# Rezoning Transportation Analysis

Petition Number: 2020-013

General Location Identifier: 14902504, 14902503

Date	Description
02-24-20	First Review (EL)
08-19-20	Second Review (KP)
09-17-20	Third Review (KP)

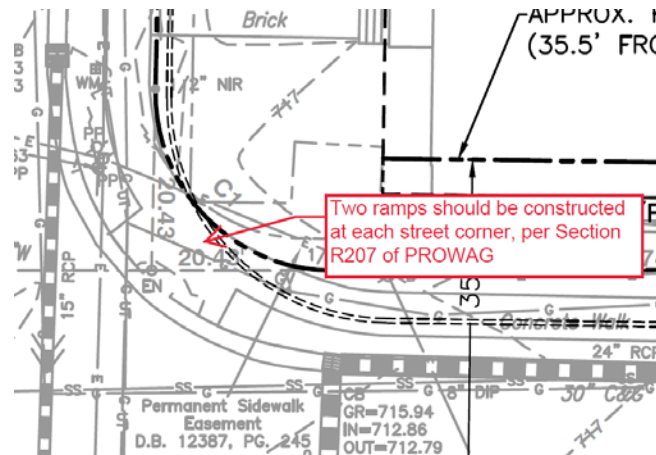
1. **Curbline** The proposed zoning district has a setback measured from back of the existing or proposed future curbline.
  - a. ~~**South Tryon Street:** The future location of curb and gutter is 41 feet from road centerline, per the council adopted CDOT Streets Map.~~
  - b. **East Cama Street:** The future location of curb and gutter is 21.5 feet from road centerline, per the council adopted CDOT Streets Map.

Label and dimension the curb and gutter from the centerline for each road.
